FINAL ENVIRONMENTAL IMPACT REPORT

DUDLEY TRIANGLE NEIGHBORHOOD
Roxbury, Massachusetts

**DUDLEY TRIANGLE NEIGHBORHOOD
FINAL ENVIRONMENTAL IMPACT REPORT**

4.0 RESPONSE TO COMMENTS

E0EA-7963 EIR Figure 2.0-2

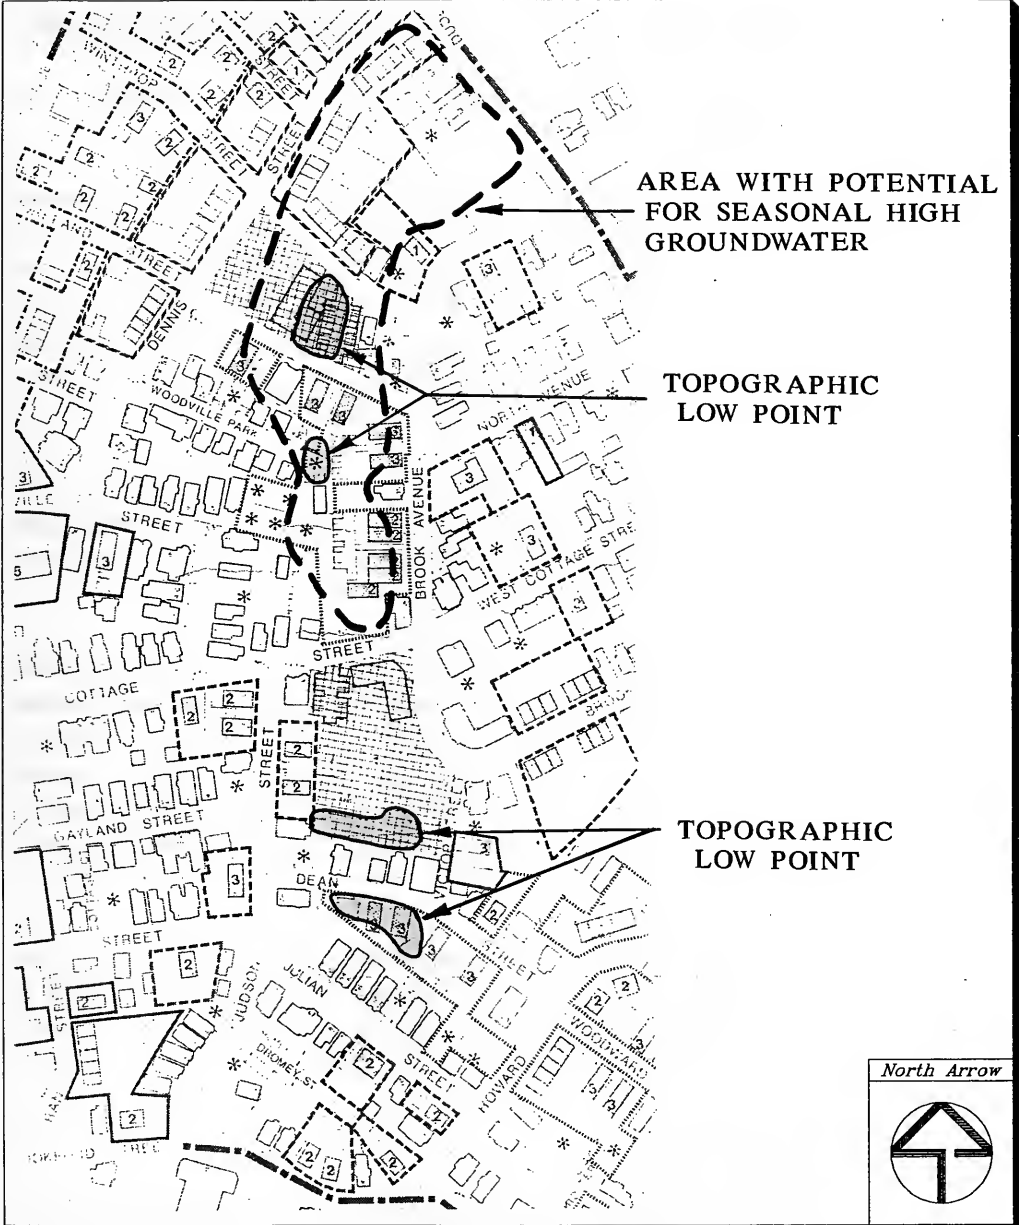
Comment 12

Comment 18 *"The DEIR indicates that some localized street flooding occurs in the
area. The proponent is requested to identify where street flooding may
occur under the proposed conditions."*

"The Final EIR should describe in more detail the mitigation measures which will be adopted to avoid the potential flooding problems."

1. Perimeter drains may be installed on the buildings within the area identified on the map (Figure 2.0-2), as having the potential for localized flooding.
2. Basements within the area may either be water-proofed or provided with a sump pump if, by subsurface investigation, it is determined that groundwater may reach within 12 inches of the proposed basement floor elevation.
3. Low areas may be raised with the installation of clean fill to bring the grade up to provide positive drainage toward the street.

The potential exists for areas within the project site to have some minor localized flooding and the potential for seasonal high groundwater. Observations were made in the field to identify these sites. Topographic information was also used to identify the areas with potential seasonal high groundwater (predominantly the area near where the Brook once existed). Figure 2.0-2 shows the various areas for potential flooding.

The proponent will provide mitigation in the areas identified on Figure 2.0-2 as having the potential for localized flooding. In areas of potential high groundwater, mitigation will be provided as needed in the form of either basement waterproofing, construction without basements, foundation drainage systems or utilizing sump pumps. The need for such mitigation will be determined by on-site subsurface investigation. Appropriate mitigation measures will be determined by the Architect responsible for preparing the project specifications.

Figure 6.0-1

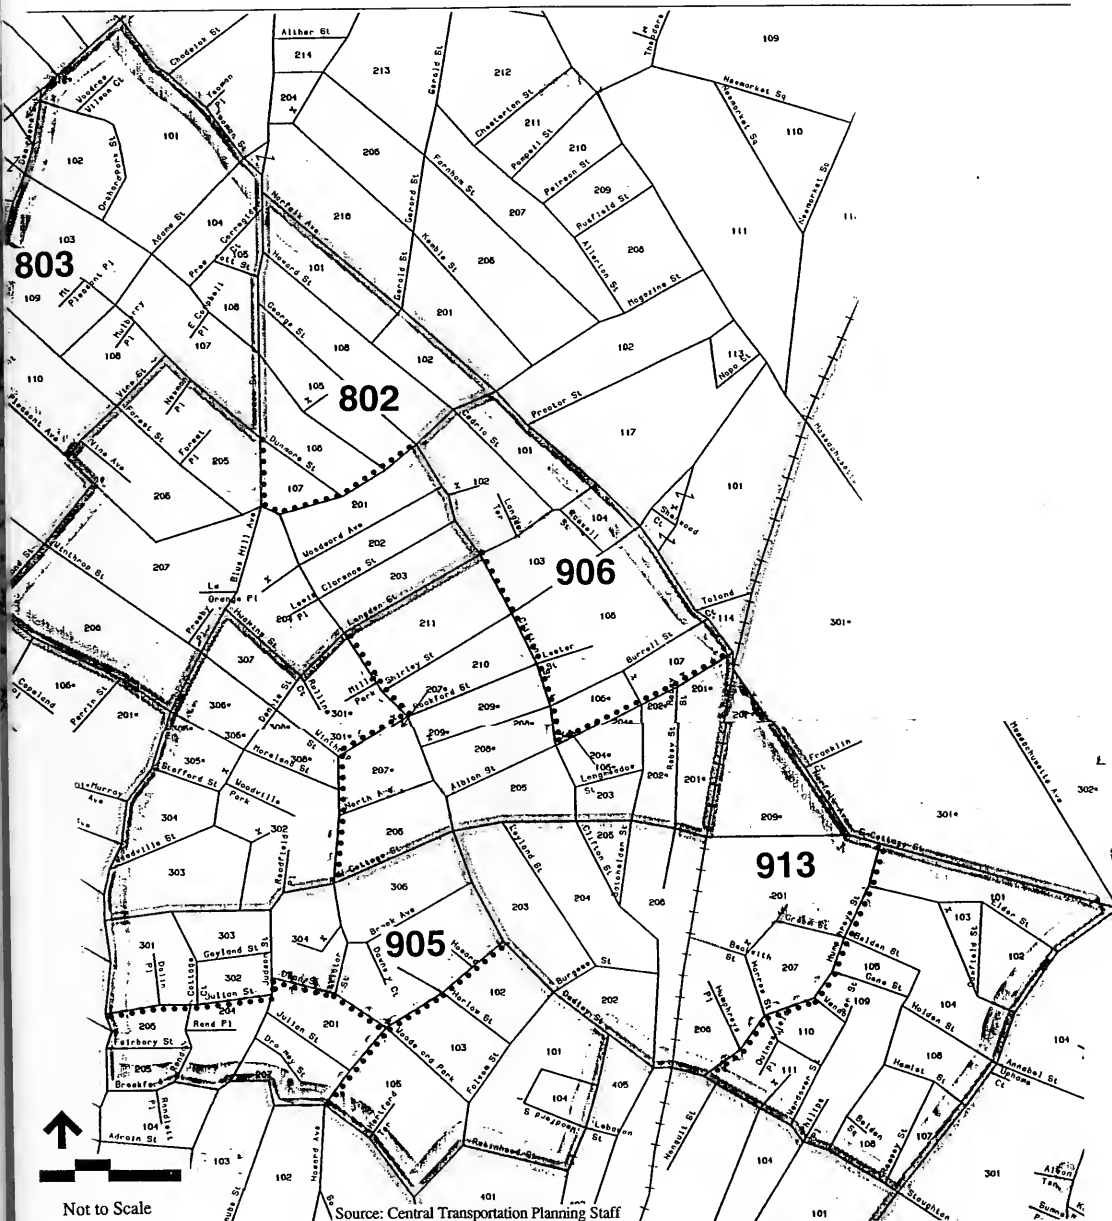
"On Figure 6.0-1, the Dudley Station National Register District also should be included on the map. Furthermore, the Historic Background discussion (section 6.3.3) does not include the Plantation Period (1620-1675) although this period is referenced on page 6-12 with regard to the potential for artifacts. These corrections should be made to the Final EIR."

Figure 6.0-1 was modified to include the Dudley Station National Register District, northwest of the project site and is included in Appendix E of this report.
